GROUP 54

CHASSIS ELECTRICAL

OUTLINE OF CHANGES

INSPECTION CHART FOR DIAGNOSIS CODES

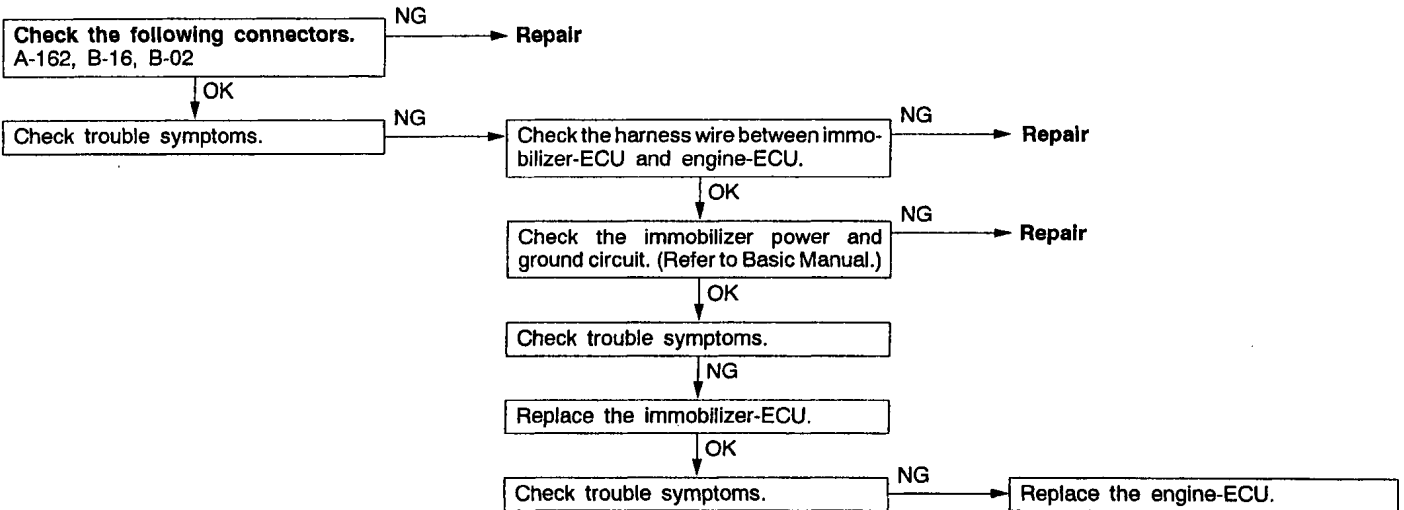
- Troubleshooting procedures have been changed as the immobilizer-ECU has been changed due to changes on the diesel engine <Diesel-powered vehicles>.
- The SRS warning lamp bulb inside the combination meter has been changed from 0.84 W to 1.4 W.
- The GDI ECO indicator lamp inside the combination meter can be dimmed by operating the rheostat.
- The defogger switch inspection procedure has been added as the timer function of the rear window defogger has been discontinued <Vehicles with manual air conditioner>.

Diagnosis code No.	Inspection items	Reference page
11	Transponder communication system	–
12	ID code are not the same or are not registered	–
21	Communication system between immobilizer-ECU and engine-ECU	54-2
